CONSTRUCTION DRAWINGS FOX RUN NATURE CENTER

EPC STORMWATER REVIEW COMMENTS
IN ORANGE BOXES WITH BLACK TEXT

SHEET INDEX	
SHEET NUMBER	SHEET TITLE
C1	COVER
C2	EXISTING CONDITIONS & DEMO PLAN I
C3	EXISTING CONDITIONS & DEMO PLAN II
C4	SITE PLAN
C5	SIGNING & STRIPING PLAN
C6	DRIVEWAY & PARKING AREA GRADING PLAN
C7	BUILDING GRADING PLAN
C8	ROAD RECLAMATION GRADING PLAN
C9	WALL PLAN AND PROFILE I
C10	WALL PLAN AND PROFILE II
C11	WALL PLAN AND PROFILE III
C12	WALL PLAN AND PROFILE IV
C13	UTILITY SERVICES PLAN
C14	OFF-SITE WATER SYSTEM PLAN
C15	ON-SITE WATER SYSTEM PLAN
C16	OVERALL STORM SYSTEM PLAN
C17	ROOF DRAIN AND PATIO PLAN AND PROFILE
C18	POND PLAN AND PROFILE
C19	DETAILS

EL PASO COUNTY
EL PASO COUNTY PARKS
FOX RUN NATURE CENTER
 DRIVEWAY & PARKING AREA GRADING PLAN

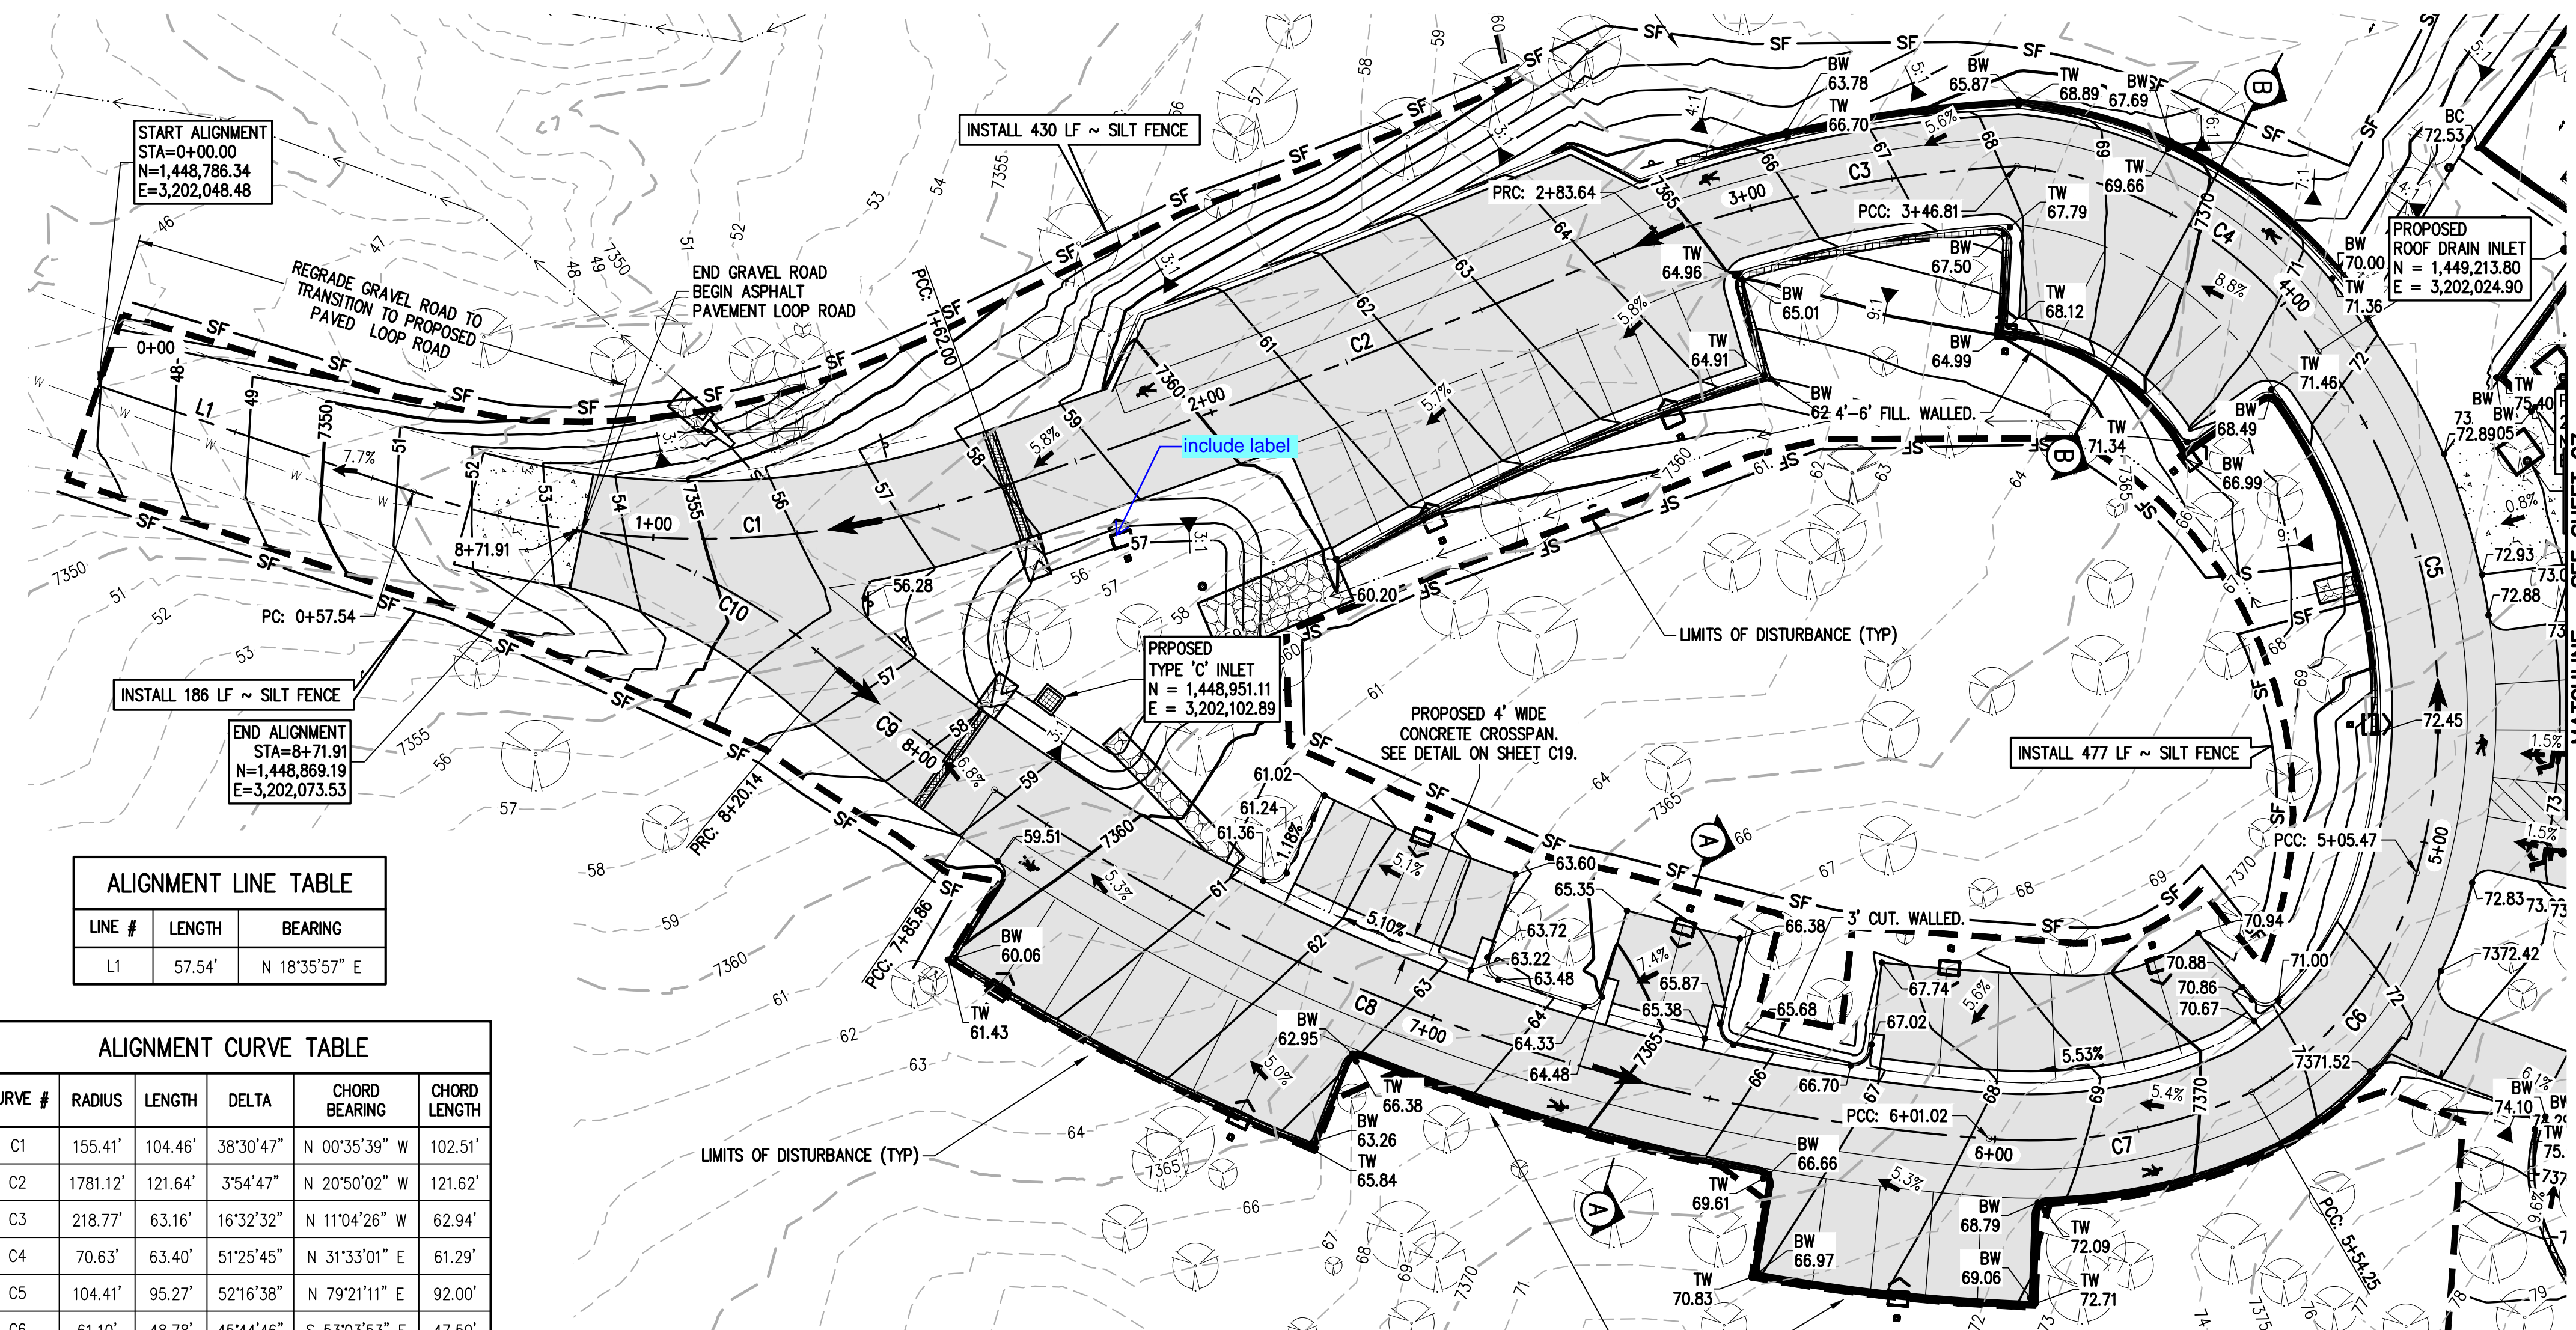
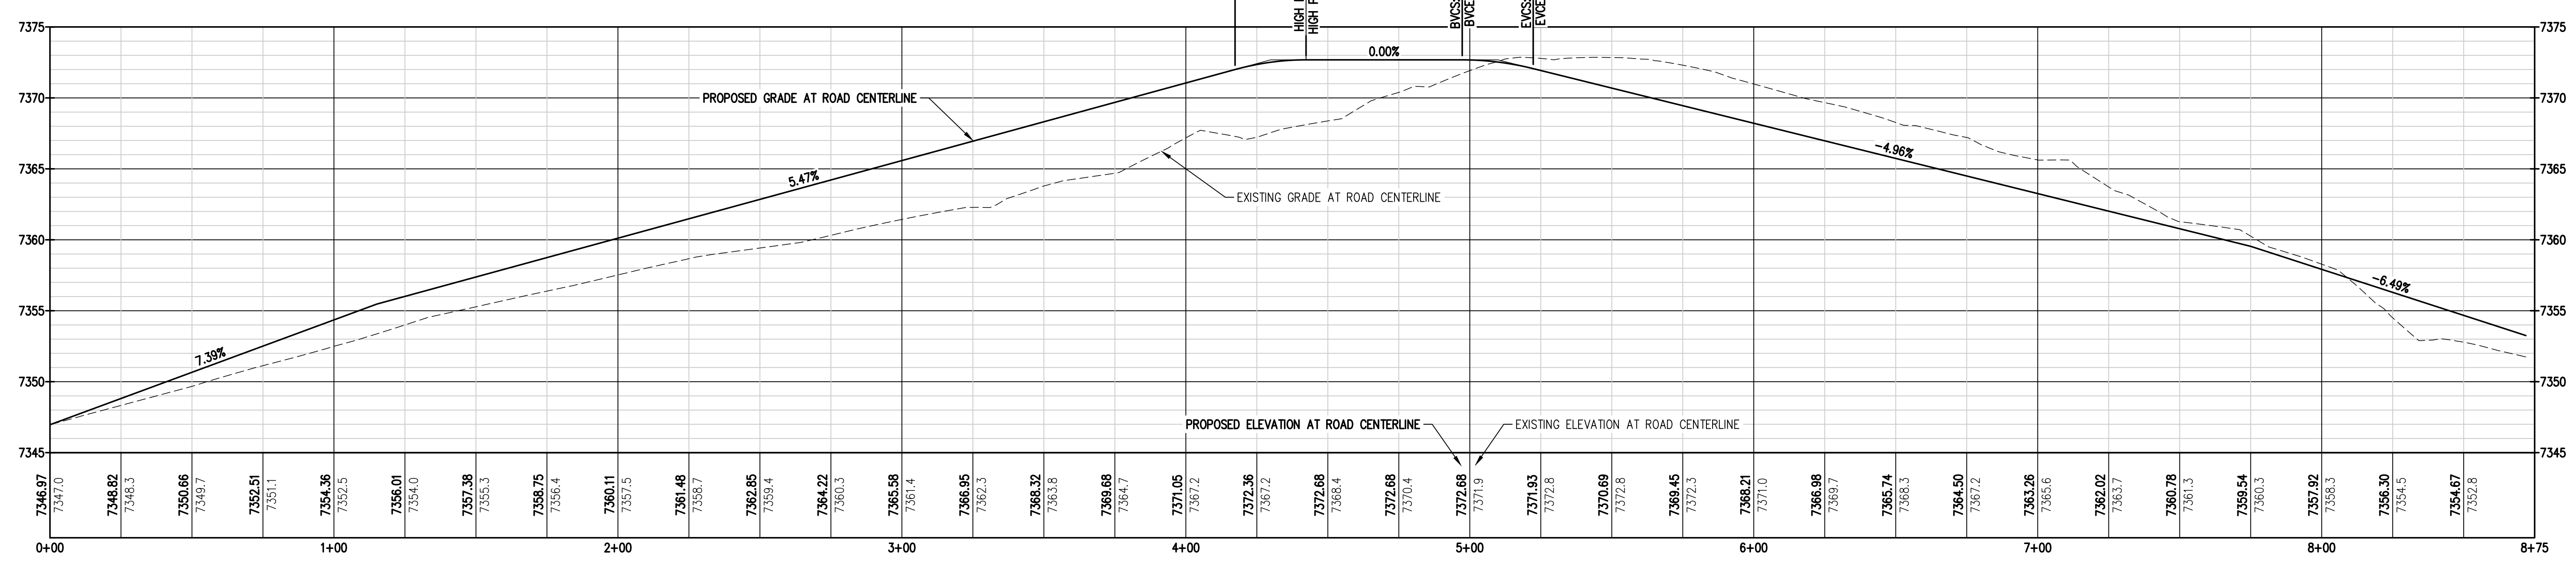
Please include all appropriate linework in the legend and turn off unneeded linework from this drawing

Please include the pavement section here

include paved width
